Rezoning Transportation Analysis

Petition Number: 2025-027

General Location Identifier: 03521305, 03521314

Date	Description
05-28-25	First Review (IW)
07-23-25	Second Review (IW)
08-26-25	Third Review (IW)
09-23-25	Fourth Review (IW) ZC
01-22-26	Fifth Review (IW)
02-19-26	Sixth Review (IW)

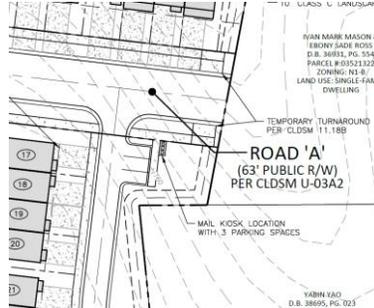
3. ~~Add a conditional note specifying "A Right of Way Encroachment Agreement is required for the installation of any non-standard item(s) (irrigation systems, decorative concrete pavement, brick pavers, etc.) within a proposed/existing City-maintained street right of way by a private individual, group, business, or homeowner's/business association. An encroachment agreement must be approved by CDOT prior to construction/installation. Contact CDOT for additional information concerning cost, submittal, and liability insurance coverage requirements."~~

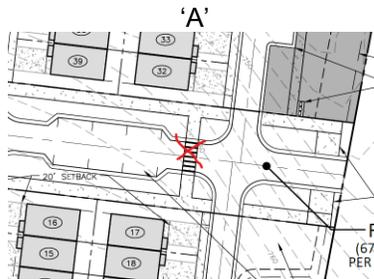
- 9. NEW COMMENT BASED ON UPDATED SITE PLAN 07/23/25:** Remove crosswalk striping on Road

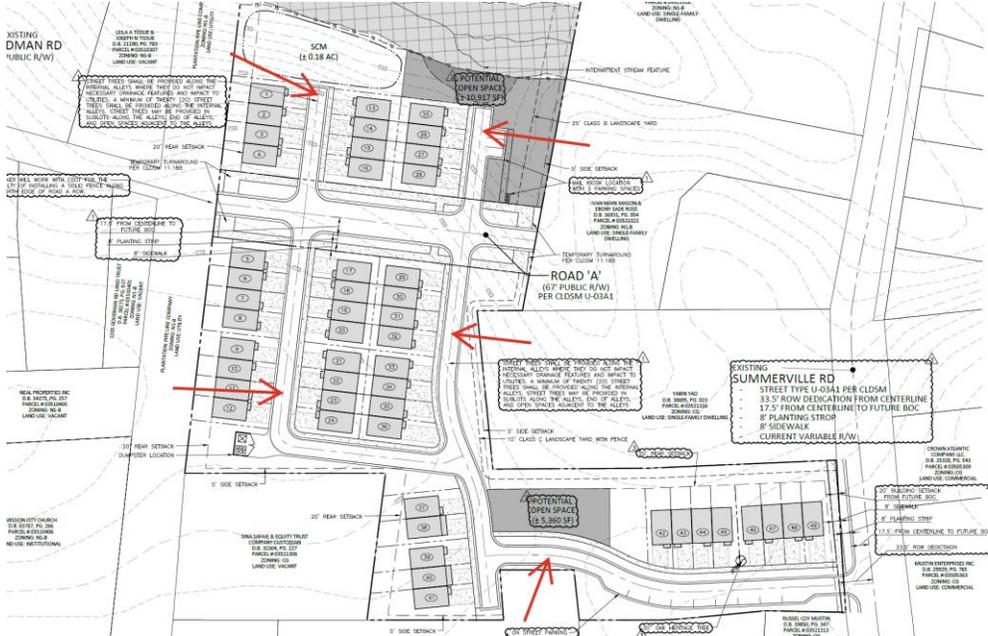
- 10. OUTSTANDING COMMENT BASED ON UPDATED SITE PLAN 01/22/26:** Revise site plan and conditional note to connect proposed ROW by extending “Road A” to existing Goodman Road as stated in “Part X. Subdivision Streets Other Infrastructure” in the UDO.

Clarifying Comment 02/19/26: Ensure all coordination with subdivision is finalized regarding roadway connection.

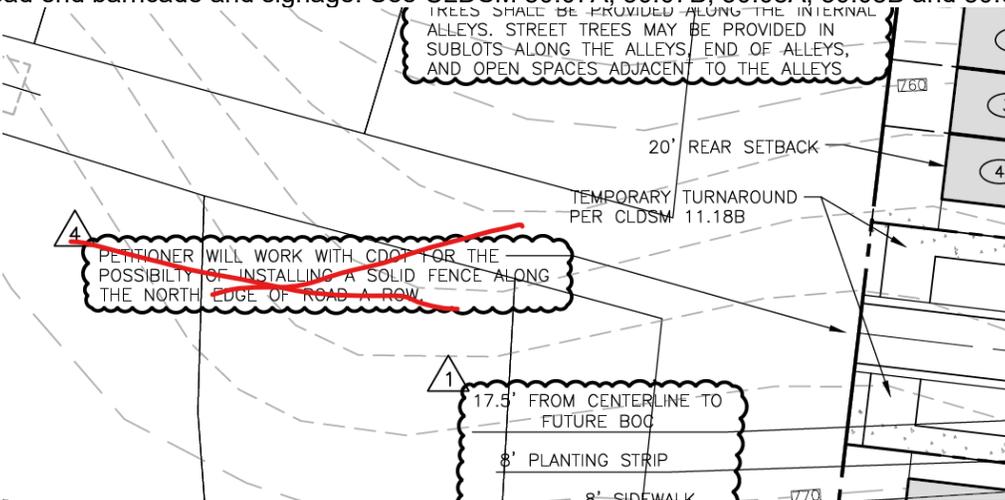
- NEW COMMENT BASED ON UPDATED SITE PLAN 02/19/26:** Revise site plan and conditional note to clearly label internal access road (non network required roadway) connecting proposed road A and Summerville Road as a private alley or private roadway. Add a conditional note identifying each.
